*RCSI Bulletin 128  
Outer Loop Alternates*

Metropolitan Ecology  
Bulletin #128

Outer Loop Alternates<sup>\*</sup>

# NYS DOT PROPOSAL

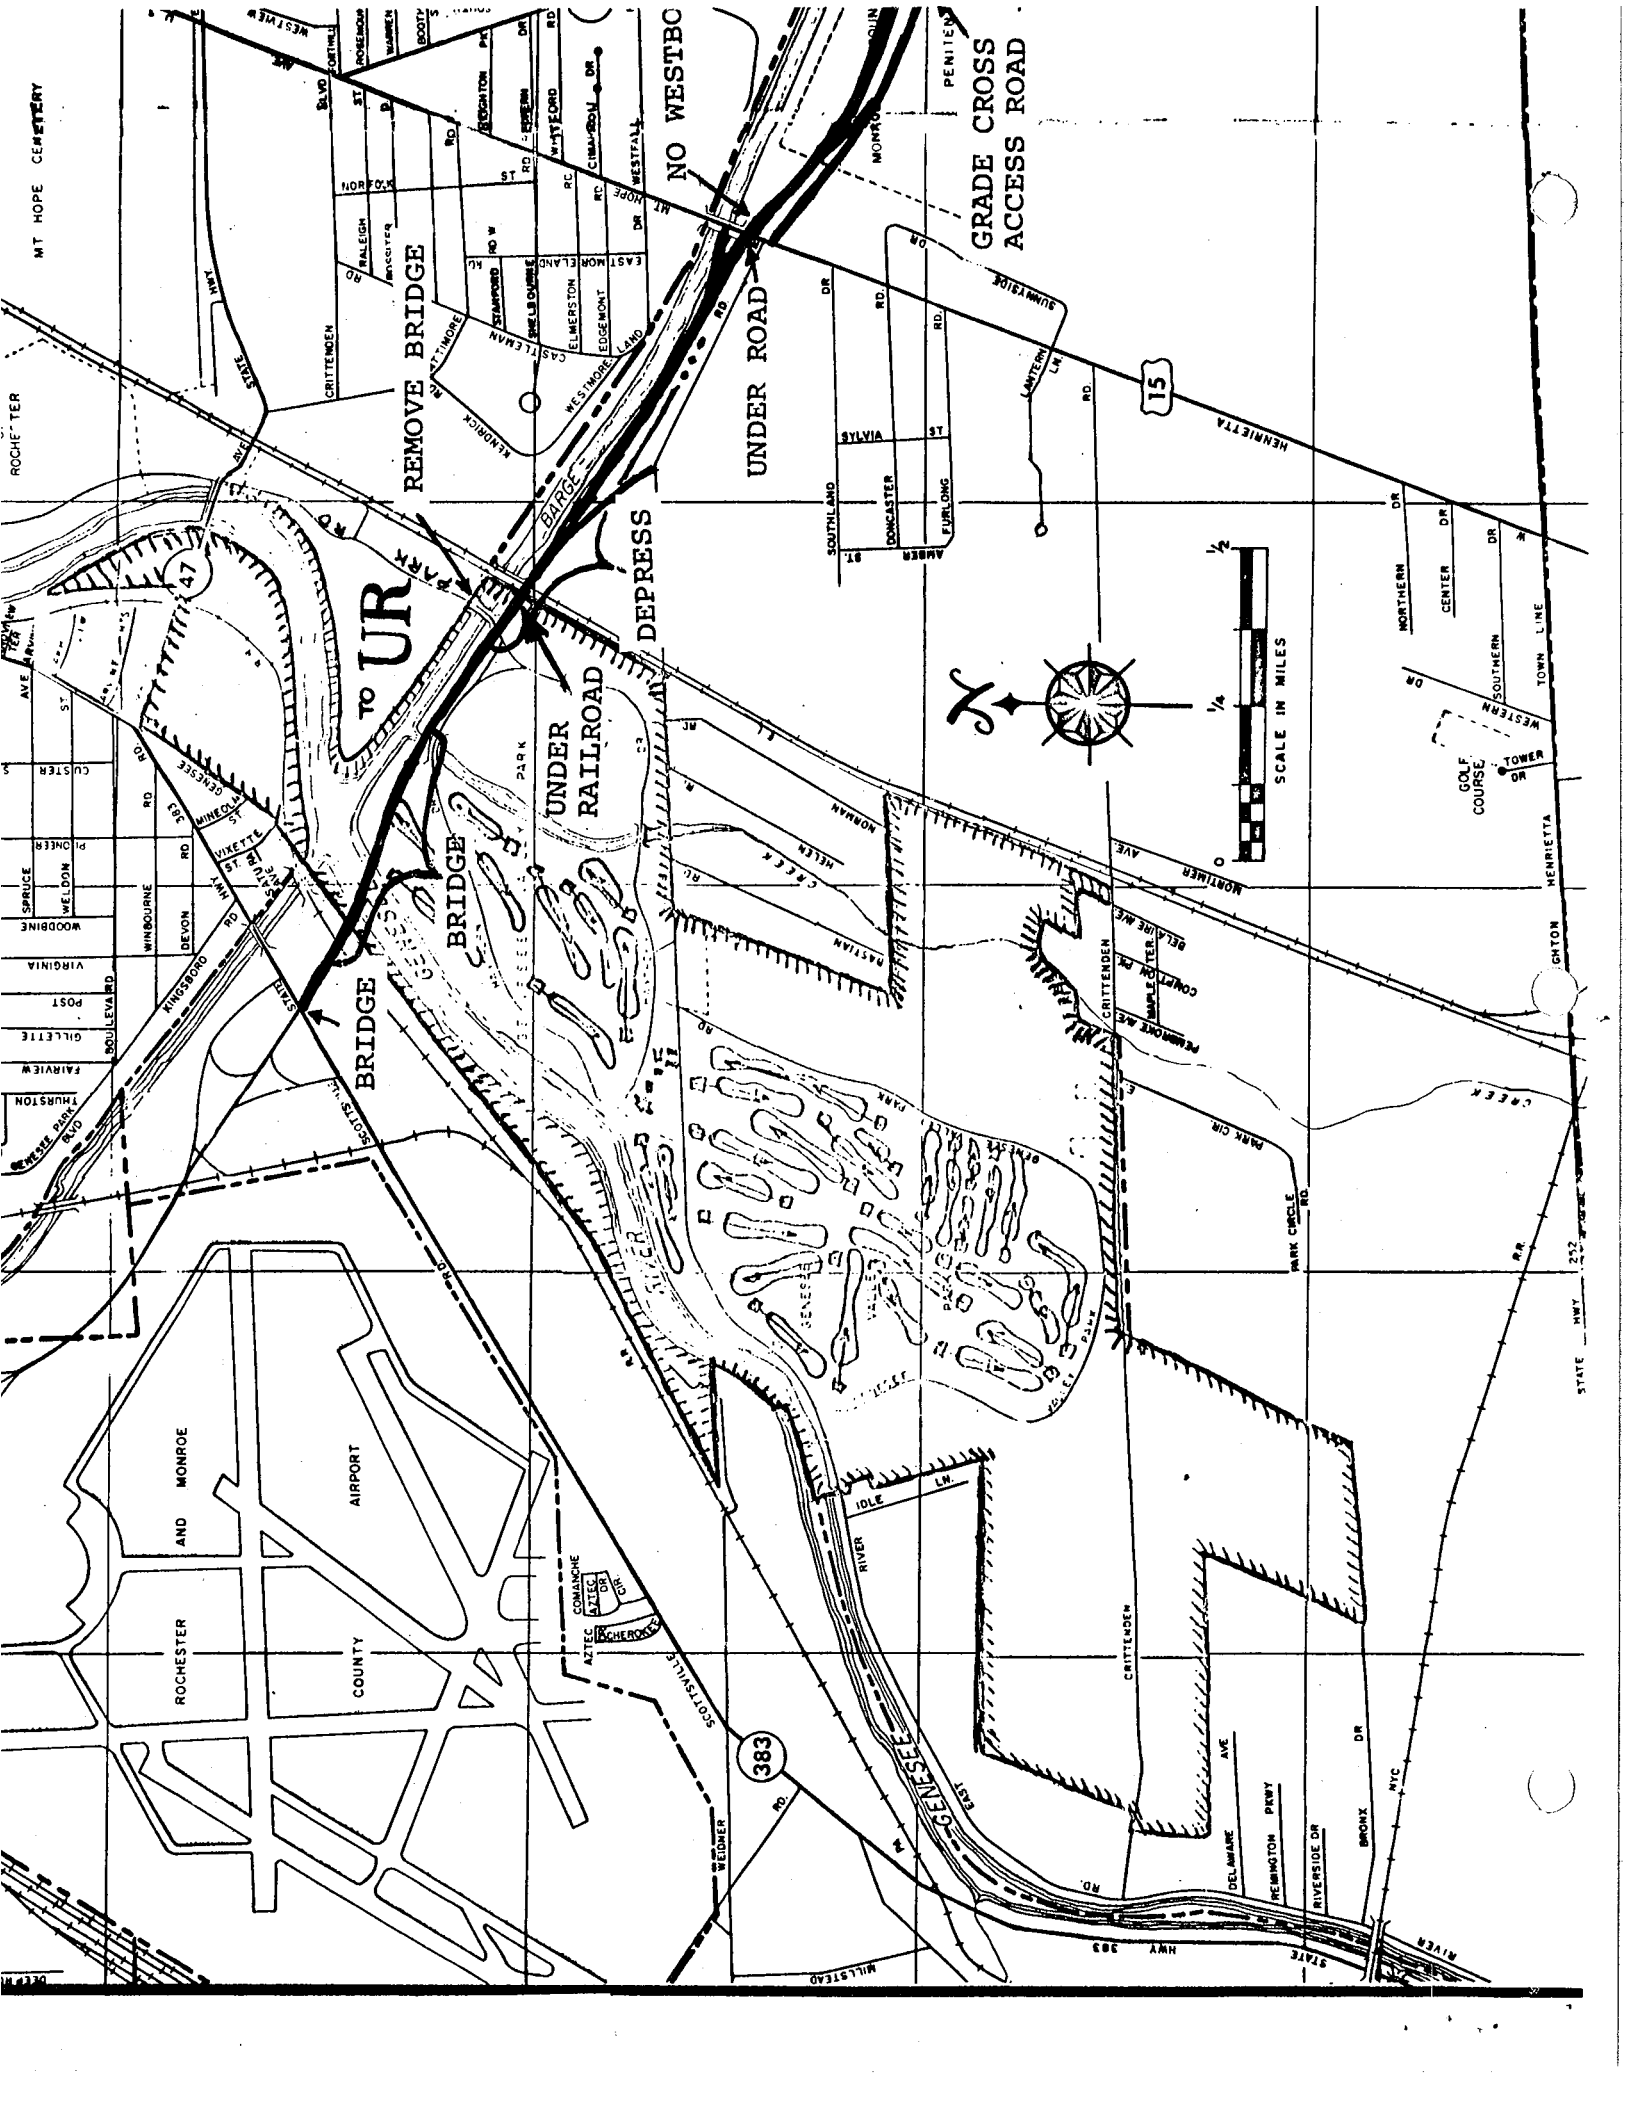
**SHORTEST ROUTE.**  
**MINIMUM PARK ACREAGE TAKEN (14.2 ACRES)**  
 No golf course holes are destroyed. One tee is raised.  
 DESIGN IS COMPLETE. no additional design cost or delay.  
 PLACES ROADWAY AT THE EDGE OF REMAINING PARK AREA.

REMOVES DIRECT VEHICULAR ACCESS FROM THE CITY. Bridge removed.  
 WEST HENRIETTA RD. MUST BE COMPLETELY CLOSED DURING CONSTRUCTION,  
 a period of about one year, while the bridge is rebuilt.  
 DESTROYS 340 MATURE PARK TREES.  
 WEST HENRIETTA RD. INTERCHANGE IS EXPENSIVE AND HAS NO WESTBOUND EXIT.

## ELMWOOD AVE ALTERNATE DISADVANTAGES

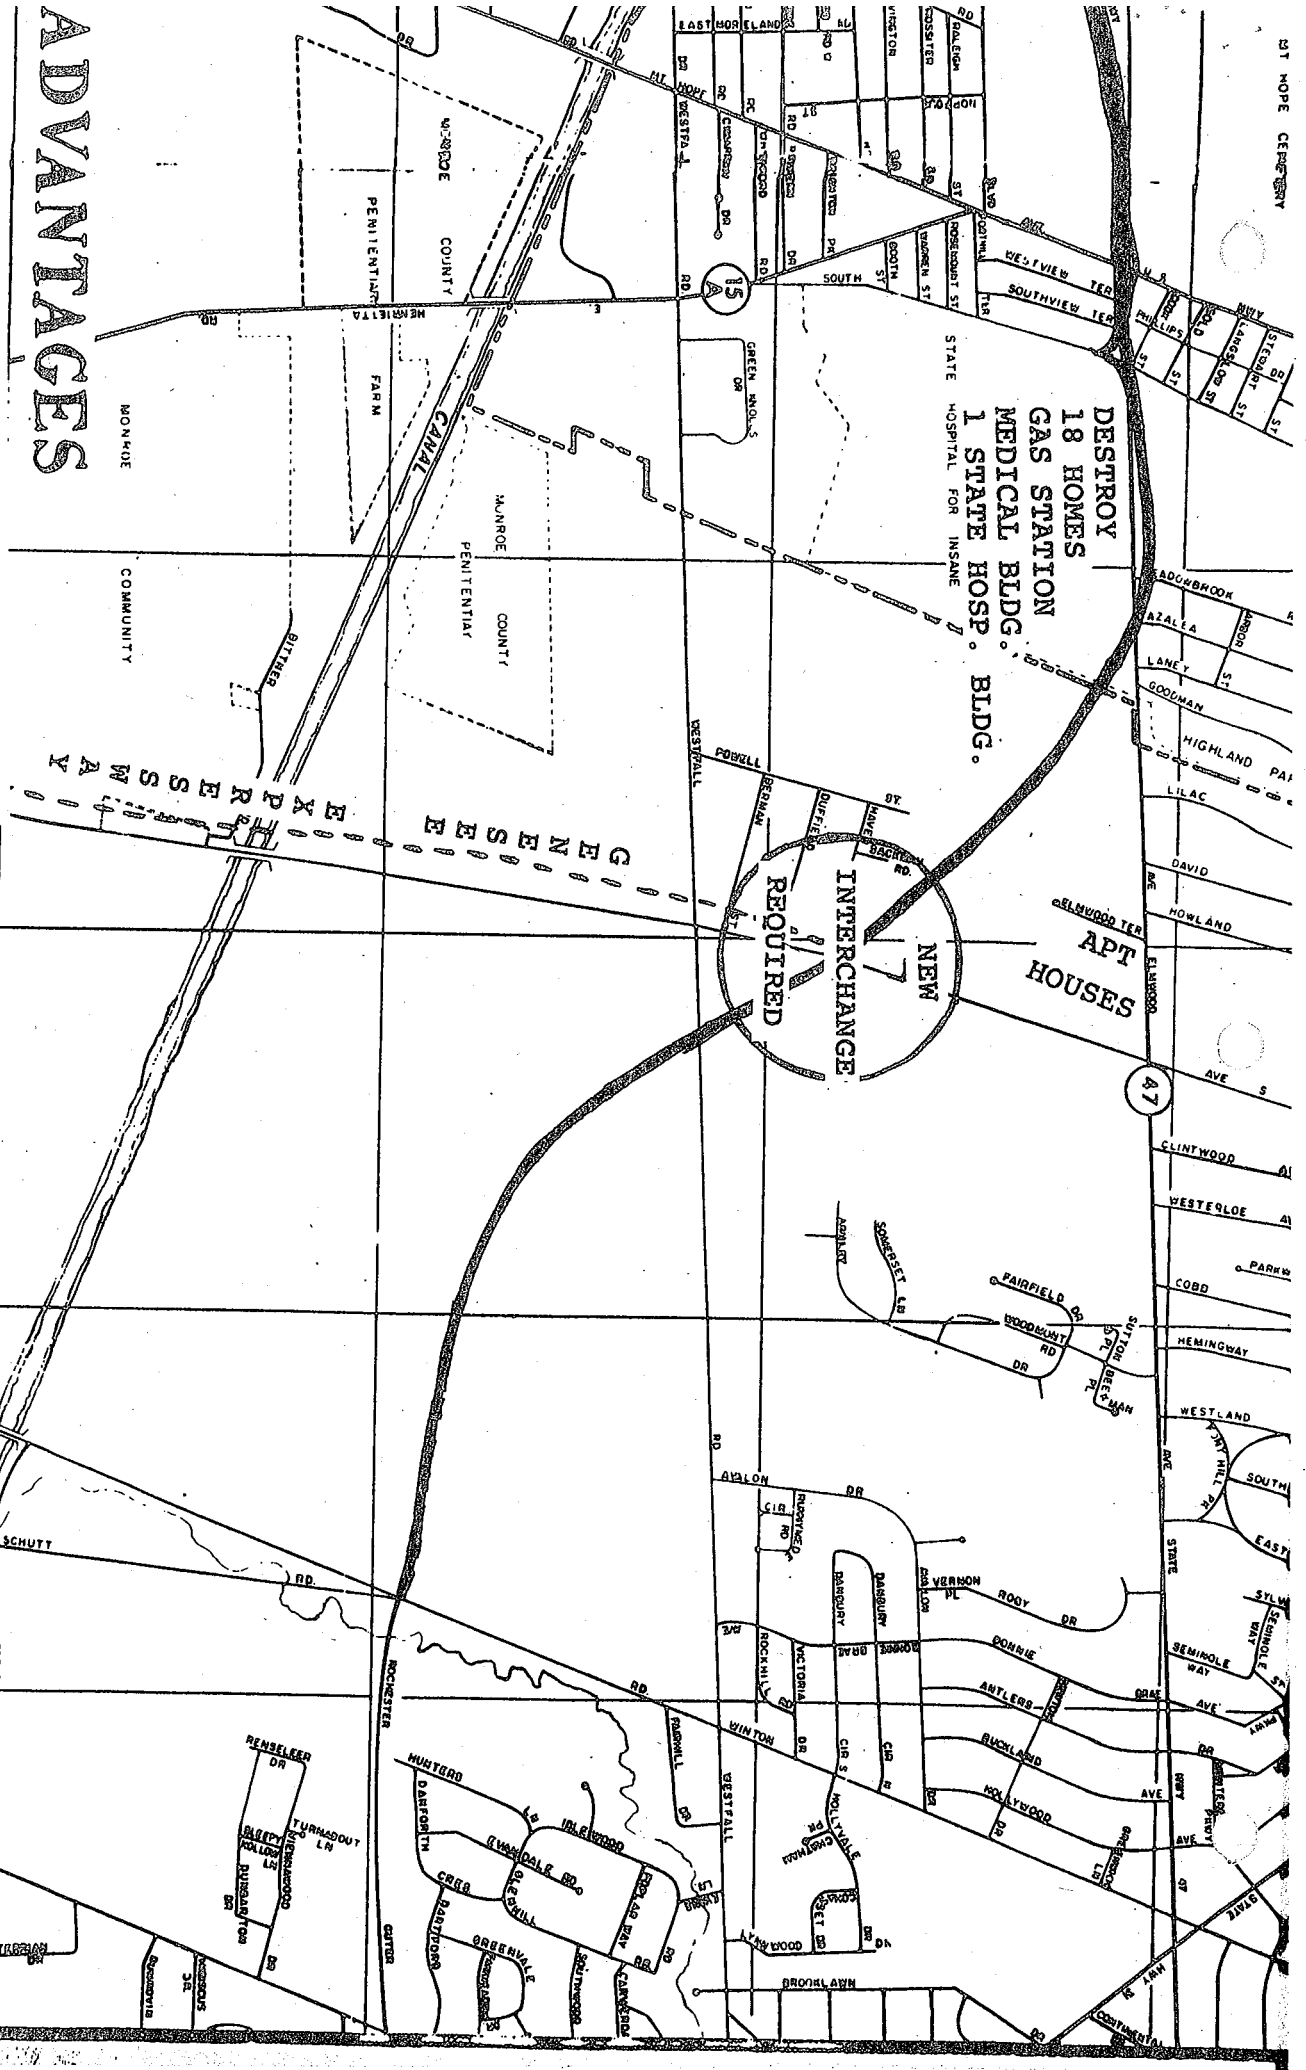
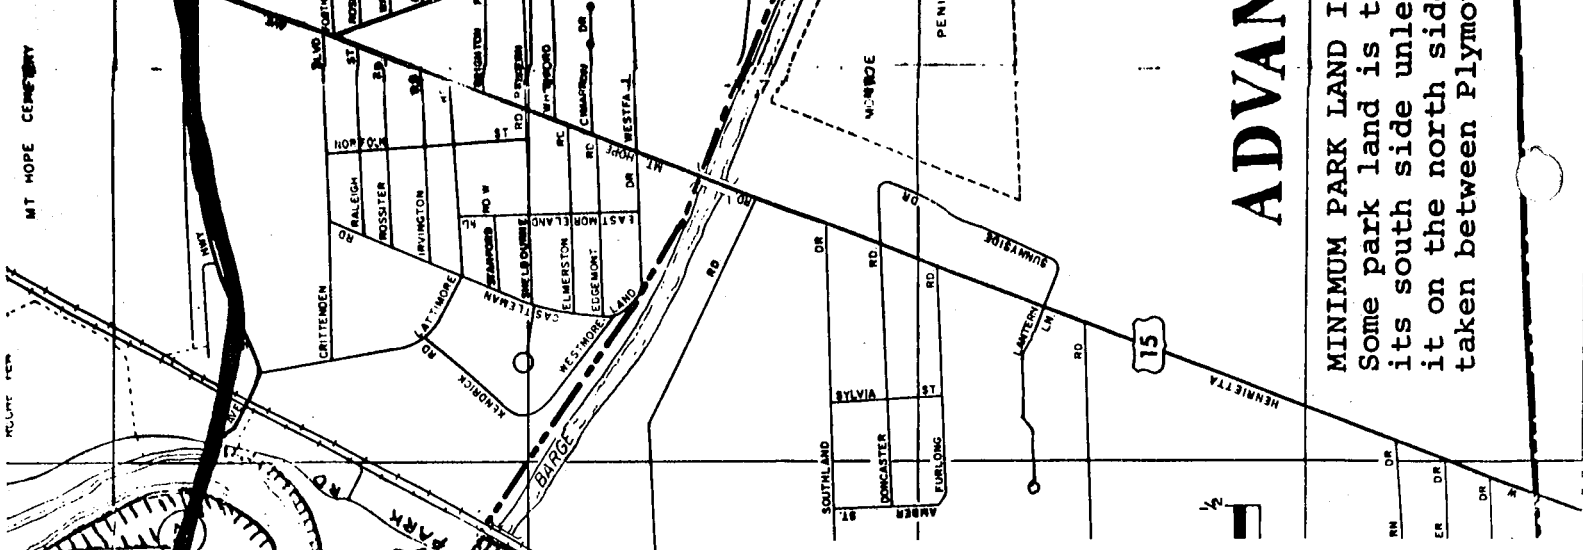
Elmwood Avenue is already congested. This alternate would add the outer loop traffic to this. The route would have to handle at least 60,000 cars a day by 1990 and therefore could not have any grade crossings or traffic signals.

East of the River this route would destroy 18 houses, 1 Medical Bldg., 1 Gasoline Station and 1 (old) State Hospital Bldg. It would pass very close to other hospital buildings and the Townhouse Motel. West of the River the least destructive route would destroy 60 more houses and cut across Scottsville Rd., Pioneer St., Winbourne and Devon and Kingsboro Roads and Genesee St. extension. A more direct route, taking the entire block between Winbourne and Devon Roads, takes 86 homes.

Neither of these counts of destroyed houses has made any allowance for interchanges since greater flexibility in their curvature makes their placement harder to predict. Therefore THESE ARE MINIMUM COUNTS. INTERCHANGES MUST INCREASE THE HOUSING DESTRUCTION since grade crossings and lights would prevent the route from handling the required total traffic volume.

Traffic must be accommodated while the new route is being built. There are no nearby routes which can take the diverted traffic.

The park land west of the river is also intensively developed, containing the boathouse, ice skating rink, and swimming pool as well as baseball, football, and soccer fields. The highway would have to be elevated to permit access to the park.

Although some advocate terminating the Genesee Expressway at the outer loop, an interchange with the expressway coming from the south would still be required.
